The final report evaluating the potential environmental consequences of the proposed Castle Mountain Project has been completed and is attached for your review. This Final Environmental Impact Statement/Environmental Impact Report (EIS/EIR) is an extension of the Draft EIS/EIR and Supplement that were previously distributed and should be used in conjunction with, rather than in place of, those documents.

The proposed Castle Mountain Project would be operated as an open pit heap leach gold mine in the Hart Mining District of the Castle Mountains located in northeastern San Bernardino County, near the Nevada border. The project site is comprised of public lands administered by the Bureau of Land Management and private lands under the jurisdiction of the County of San Bernardino.

**CASTLE MOUNTAIN PROJECT FINAL EIS/EIR**

**WATERSHED AREA AFFECTED BY  
CASTLE MOUNTAIN PROJECT  
MINE PITS**

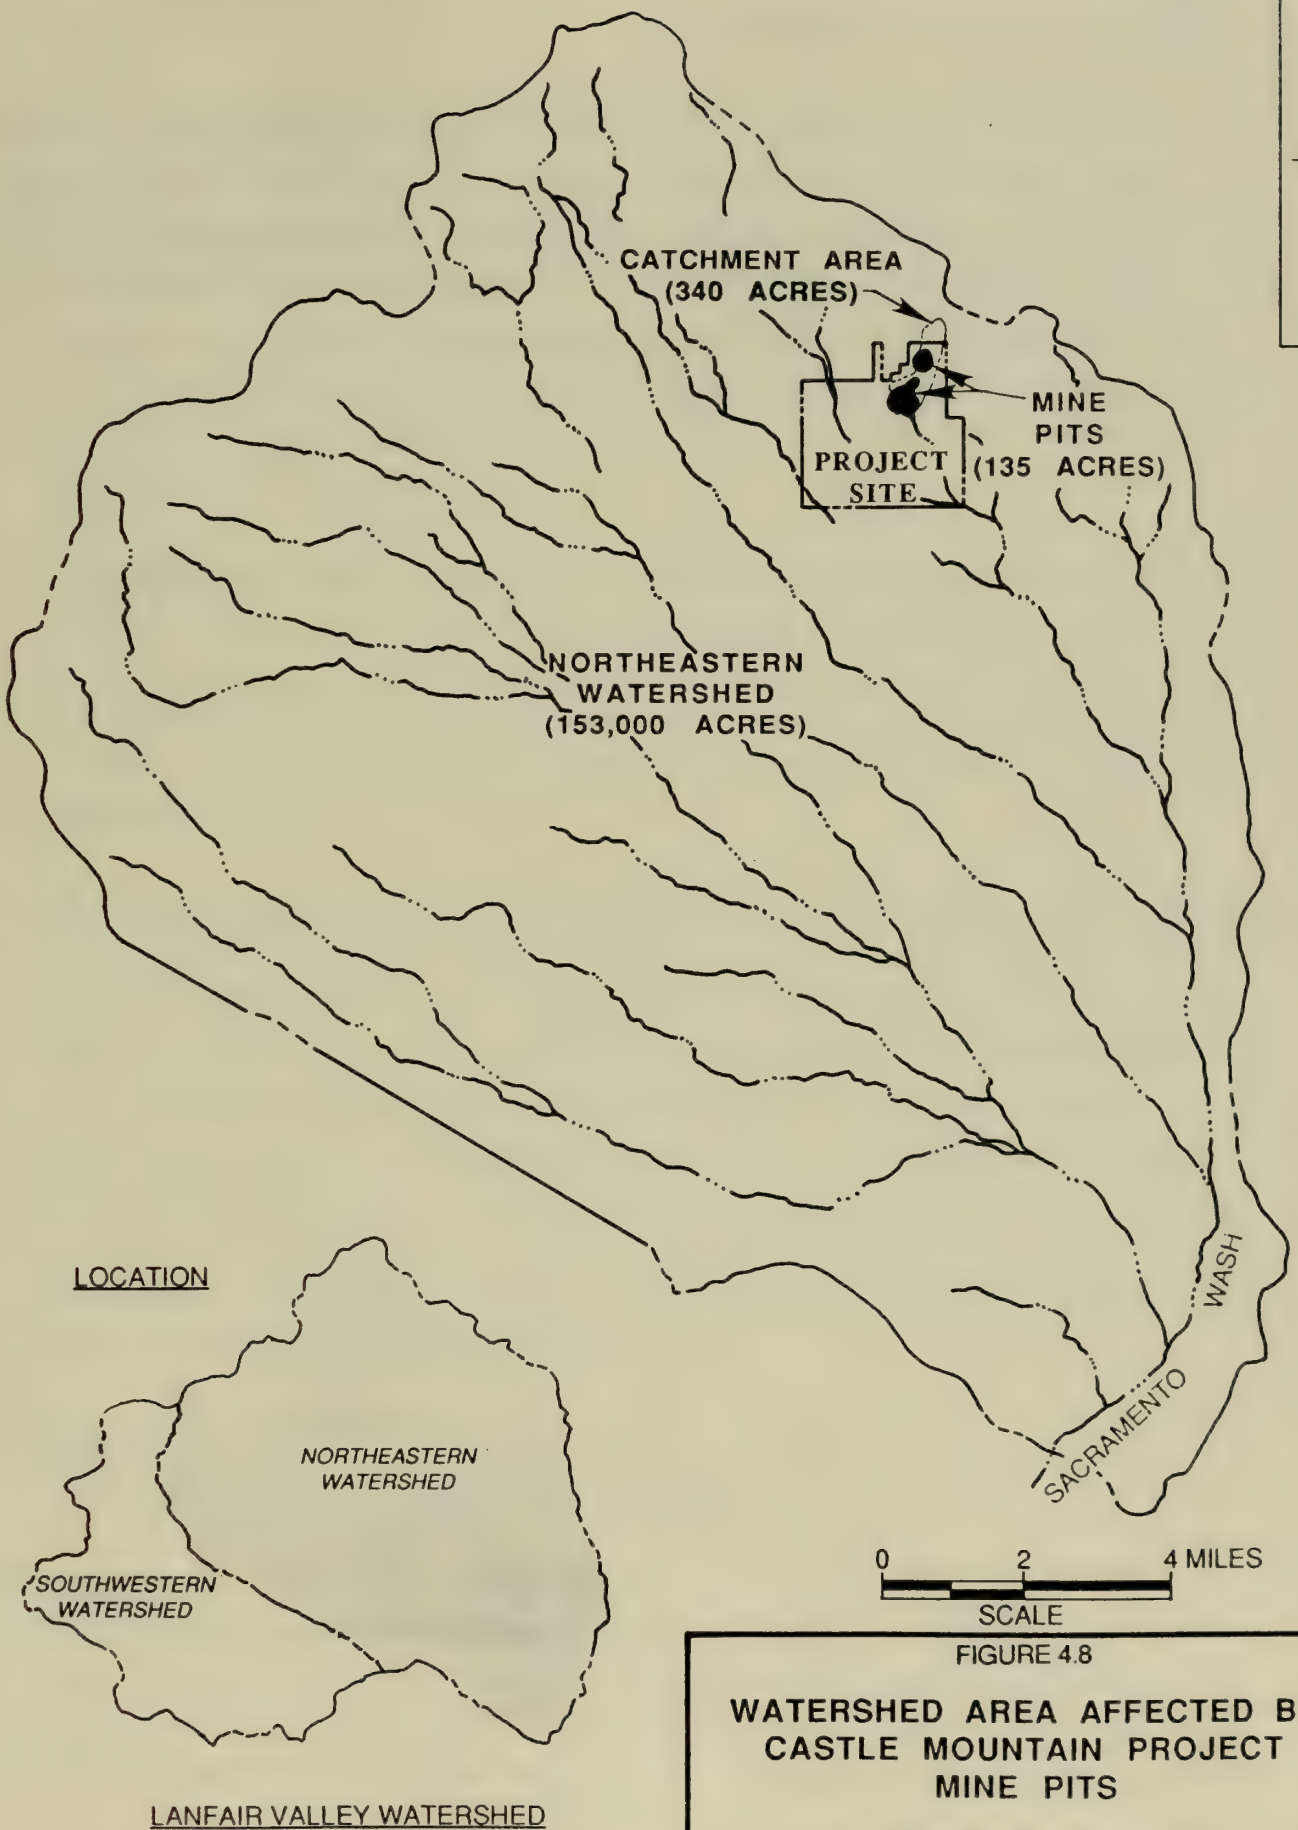
2. It is recognized that surface flows from occasional precipitation would enter the mine pits. However, as the mine pits are located at the apex of a drainage basin, the volumes diverted into the pits would be minimal, as shown in Figure 4.8 (Watershed Area Affected by Castle Mountain Project Mine Pits) of this Final EIS/EIR. The catchment area affected by the pits would be approximately 340 acres, of which 135 acres would be occupied by the mine pits. Water entering the pits would not be lost, but would support vegetation on the benches and floor of the pits. Some of the surface water collecting in the pits would undoubtedly enter the ground through fractures in the rock walls and benches of the mine pits. The benefit to be derived from reestablishing surface flow through the mine pits is therefore questionable.

**FIGURE 4.9**

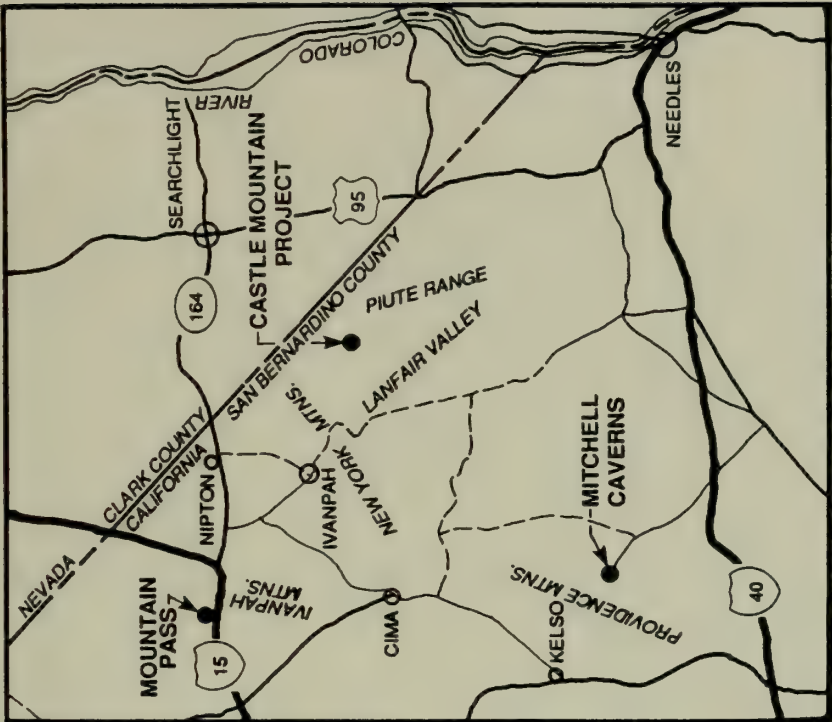
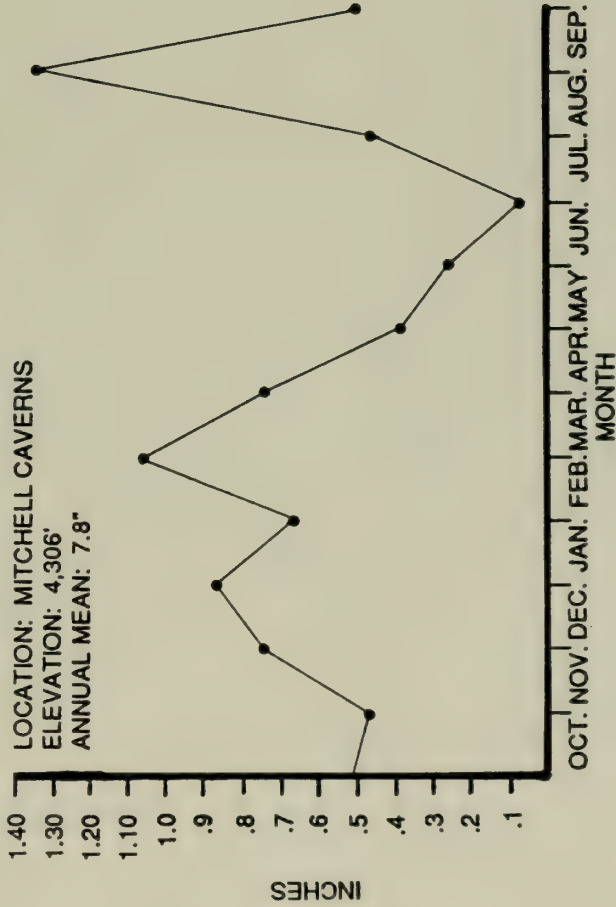
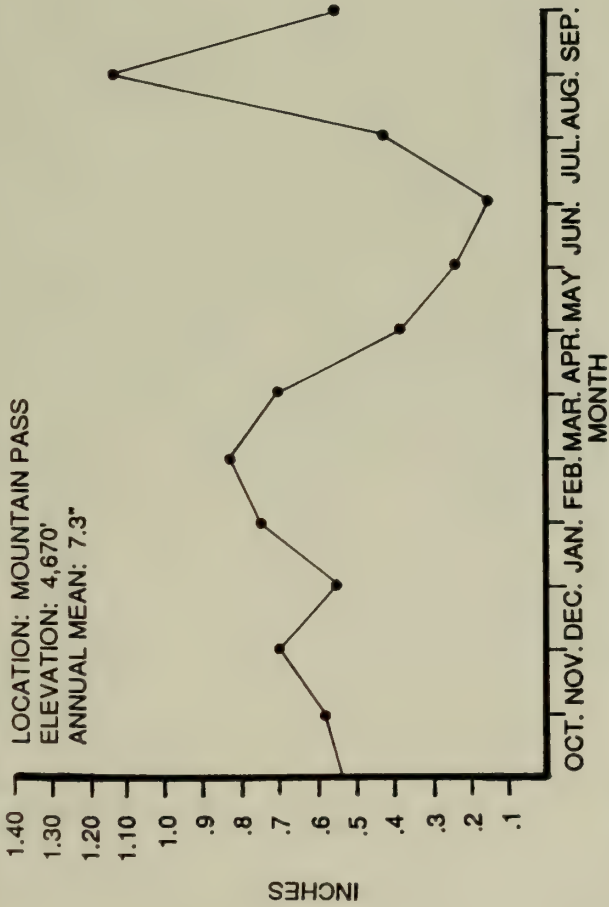
2. The locations of the regional California, Arizona and Nevada precipitation stations used by Rush and Huxel are shown on Figure 4.9 (Location of Precipitation Stations in the Vicinity of Lanfair Valley). In response to the assertion, that the database is not conservative, data were obtained for two additional precipitation stations, Mountain Pass and Mitchell Caverns, which are closer to Lanfair Valley. The location of these stations is shown on Figure 4.9. Information respecting elevation, mean annual rainfall, and seasonal variation in precipitation, for these two locations are shown in Figure 4.10 (Monitoring Data at Mountain Pass and Mitchell Caverns Weather Stations).

FIGURE 4.11

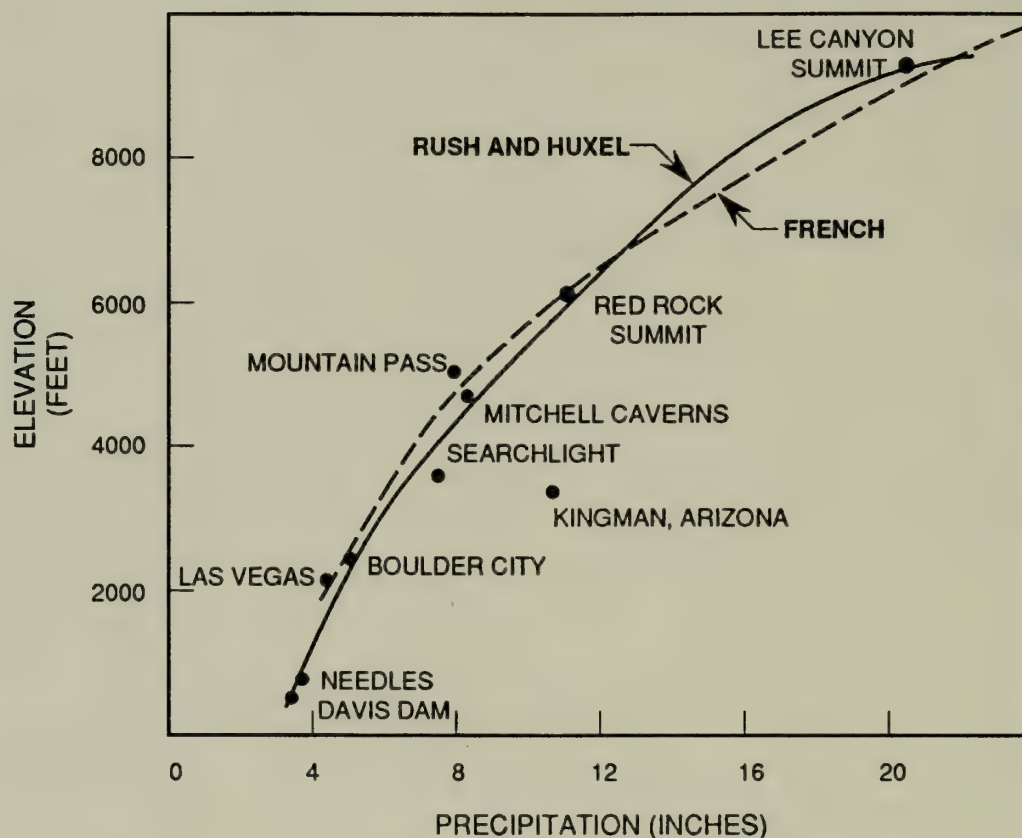
3. Figure 4.11 (Relationship of Precipitation to Elevation) is Figure 3.1 of the Technical Report, with data for Mountain Pass and Mitchell Caverns added. The close agreement to the baseline data confirms the applicability of the Rush and Huxel data for use in estimating precipitation levels in Lanfair Valley. Moreover, a further comparison of seasonal variations in rainfall for these two stations, shown in Figure 4.10, shows very similar characteristics, indicating that regional conditions in the area near Lanfair Valley do not greatly vary. Based on both the original and new data, there appears to be no basis for assuming that precipitation in Lanfair Valley will be appreciably different from that estimated by The Mark Group. Therefore, it is concluded that the mean annual precipitation (isohyetal) data presented in the Technical Report (Figure 3.9, Mean Annual Precipitation), which also was presented in Friewald's 1984 paper, is reasonable for estimating water balance conditions.
